UNITED STATES PATENT AND TRADEMARK OFFICE

APPLICATION NO.	FILING DATE	FIRST NAMED INVENTOR	ATTORNEY DOCKET NO.	CONFIRMATION NO.
10/087,302	02/28/2002	Morten Eriksen	43708.14	3786

Office Action Summary

DETAILED ACTION

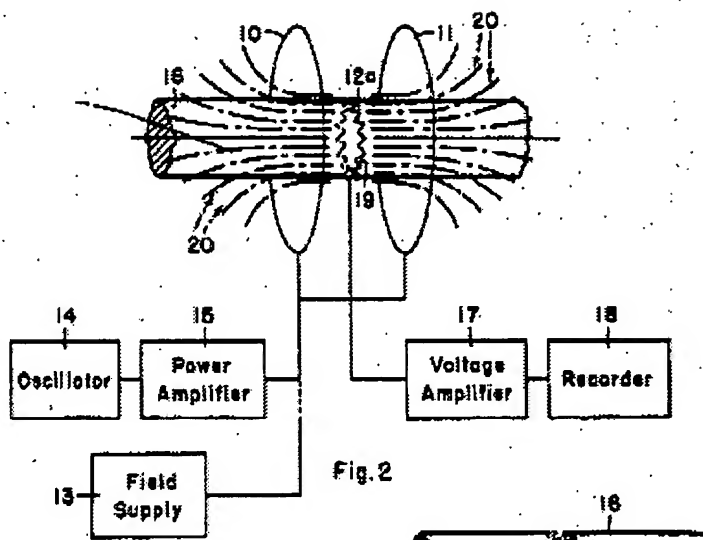
Claim 1: Goldberg et al disclose a device for measuring the movement ("displacements" or "changes in cross-sectional areas") of an object (see col. 1, lines 6-10 and lines 45-50 and see fig. 2 below) comprising: means 13 for creating time-varying magnetic fields at least large enough to surround the object (see col. 6, lines 55-62); electrical circuits 10 and 11 adapted to conform ("embracing" or "contacting engagement") to the surface of the object (see col. 6, lines 47-52); and voltage monitoring means 18 connected to the electrical circuits, whereby motion of the surface creates a measurable change in induced voltage in the circuits that correlates to the movement of the object (see col. 6, lines 27-45).

Claim 5: Goldberg et al disclose coils 10 and 11 (see fig. 2), which are capable of configuring to the thoracic region and the abdominal region of a human body (see col. 2, lines 30-39).

Claim 9: Goldberg et al disclose the current generating means (field supply 13), comprises a constant current circuit to maintain the current in the conductive coil means 10 (see fig. 2).

Claim 10: Goldberg et al disclose the current generating means (field supply 13) comprises a signal generator and a constant current amplifier electrically connected to the coil means which is receiving the generated current (see fig. 2).

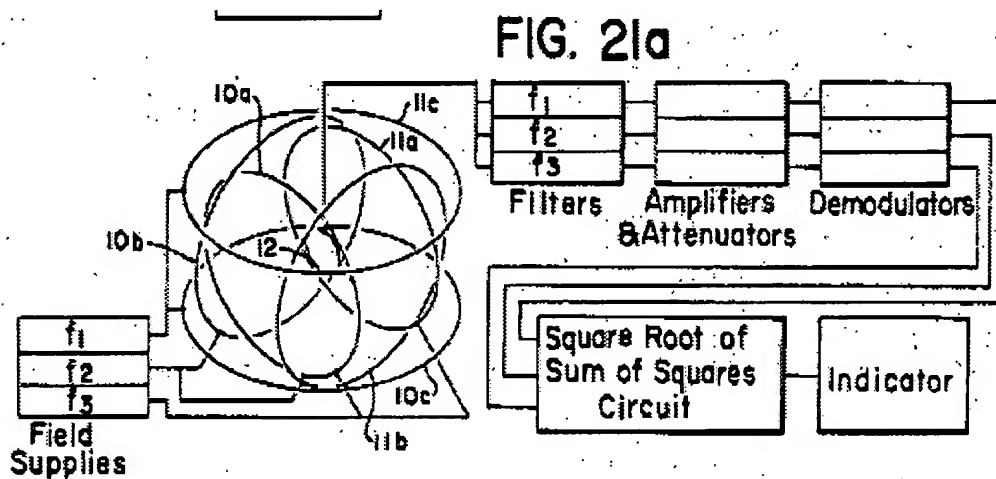
Claim 2: Goldberg et al disclose a computing means (square root of sum of squares circuit, see fig. 21a) suitable for performing a series of algorithmic steps to calculate the volume change of the object from the measured induced voltage (see col. 16, lines 22-39).

Claims 13-15: Goldberg et al disclose the fixed coil means 10 comprises a plurality of small coil elements 10a, 10b, 10c (see fig. 21a).

Claim 23: Goldberg et al disclose the conductive coil means comprises a plurality of coil loops (see fig. 21a).

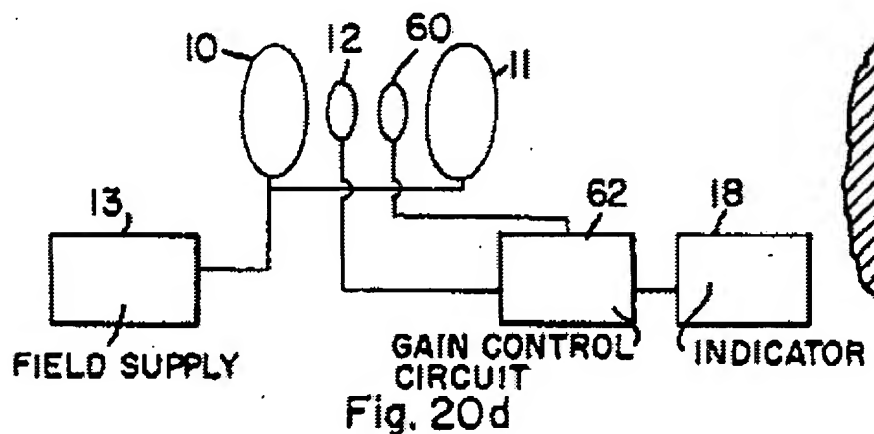
Claim 6: Goldberg et al disclose sensing and control means (control circuit 62) for controlling operation of the device, the sensing and control means being electrically connected to the conductive coil means 10, the fixed coil means 11, and the current generating means 13 (see fig. 20d below).

Claims 7 and 8: Goldberg et al disclose sensing and control means (gain control circuit 62) (see fig. 20d).

Claim 11: Goldberg et al disclose the sensing and control means (control circuit 62) (see fig. 20d).

Claim 18: Goldberg et al disclose the computational means (indicator 18) for receiving a signal representative of sensed volume of the portion of the mammal and for converting the signal to true volume values (see fig. 20d).

Fig 20e

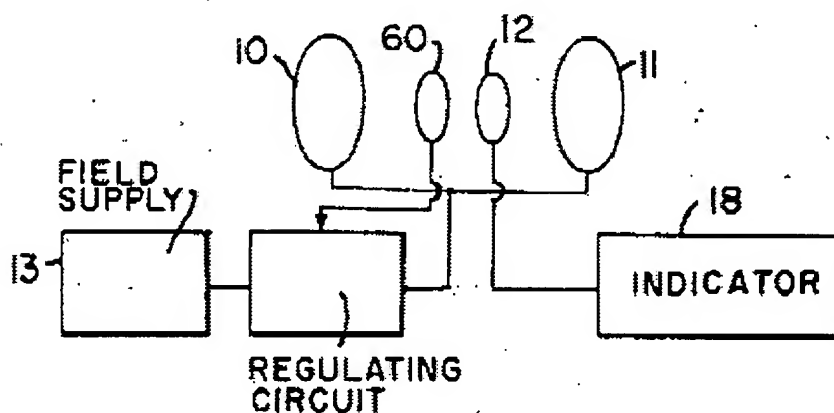
Claims 24 and 25: Goldberg et al disclose sensing and control means (gain control circuit 62 or regulating circuit) of controlling operation of the device (see fig. 20d and 20e).
